Dresden Nuclear Power Station, Units 2 and 3
Facility Operating License Nos. DPR-19 and DPR-25
NRC Docket No. 50-237 and 50-249

Quad Cities Nuclear Power Station, Units 1 and 2
Facility Operating License Nos. DPR-29 and DPR-30
NRC Docket Nos. 50-254 and 50-265

Subject: Additional Information for the Review of the License Renewal Applications
for Dresden Nuclear Power Station, Units 2 and 3 and Quad Cities
Nuclear Power Station, Units 1 and 2

Attachment : Response to Request for Additional Information – LRA Sections 2.4, 3.2, 3.5, 3.6, and 4.7, and Aging Management Programs

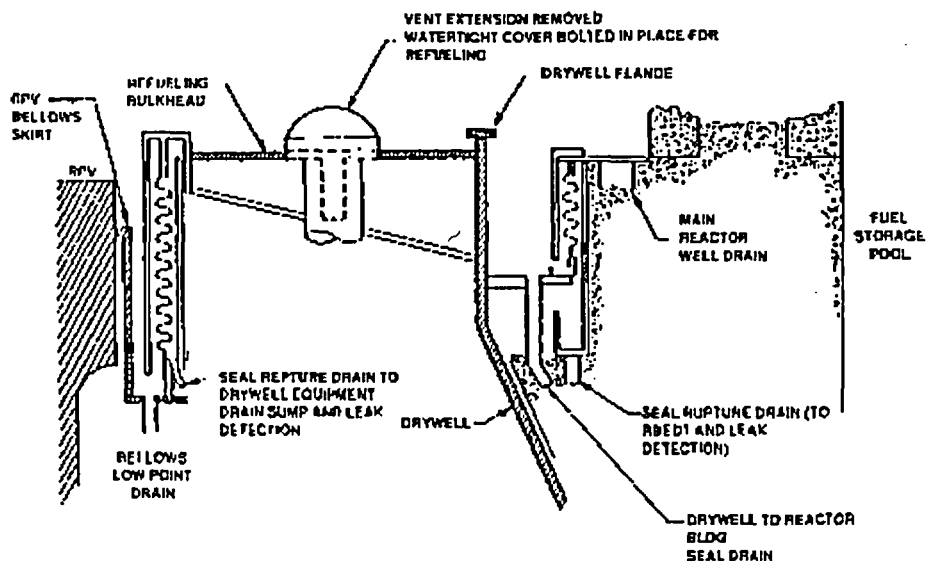
From the applicant's response, it appears to the staff that leakage past the RPV-to-drywell refueling seal and subsequent discovery of this condition is not of great concern to the applicant. There apparently is no formalized procedure or requirement to check for leakage after flooding the reactor cavity. Water seepage past the moisture barrier at the steel/concrete juncture at the bottom on the inside of the drywell has the potential to initiate corrosion on the inside surface. Coupled with the known corrosive condition on the outside surface, continued demonstration of drywell structural adequacy would become more complex and uncertain.

The staff's position is that the RPV-to-drywell refueling seal is within the scope of license renewal and is subject to an aging management review. This is Open Item 2.4.1.2-1.

Leakage past the RPV-to-drywell refueling seal is collected and directly piped by design to the drywell equipment drain sump. Refer to the following drawing.

A high flow switch in the drain line to the equipment drain sump provides an alarm in the control room if flow >1 gpm is detected (there is an additional high level alarm on the sump itself). The annunciator response procedure directs actions to quantify/mitigate the leakage, since excessive flow through the drain line could eventually result in leakage into the drywell.
